MAINE TURNPIKE AUTHORITY

ADDENDUM NO. 1

CONTRACT 2025.17

BRIDGE REPAIRS

SHEET NUMBER: S-05

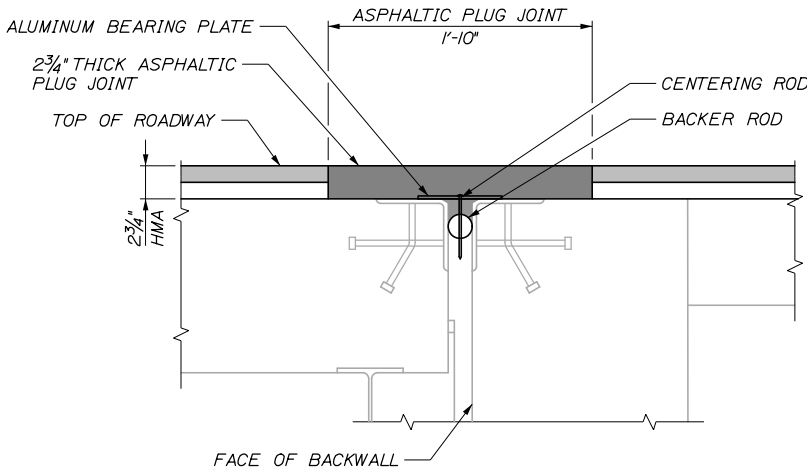
The Contractor shall delete sheet 18 (S-05) and replace with sheet 18 (S-05), Revision 1, attached. Notes and annotation pertaining to protective shielding and waterproofing membrane are revised.

Answer: The shielding shall be removed after use, not kept in place. Therefore, the Contractor does not have to design a stay in place shielding system. Contractor is required to submit working drawings to the Resident for approval. See attached Plan updates associated with this change.

- SHIELDING SHALL BE PROVIDED FOR ALL REPAIR LOCATIONS OVER LIVE TRAFFIC. SHIELDING SHALL EXTEND THE FULL BAY WIDTH UNDERNEATH THE REPAIR AND LONGITUDINALLY TO 3 FT BEYOND THE REPAIR.

- CONTRACTOR SHALL PROVIDE THE NECESSARY SHIELDING TO PROTECT REMOVED CONCRETE AND NEWLY PLACED CONCRETE FROM ENTERING THE TRAVEL LANES AND SIDEWALKS OF FOREST AVENUE. CONTRACTOR SHALL SUBMIT WORKING DRAWINGS FOR THE SHIELDING TO THE RESIDENT FOR APPROVAL. PAYMENT SHALL BE INCIDENTAL TO RELATED CONTRACT ITEMS.
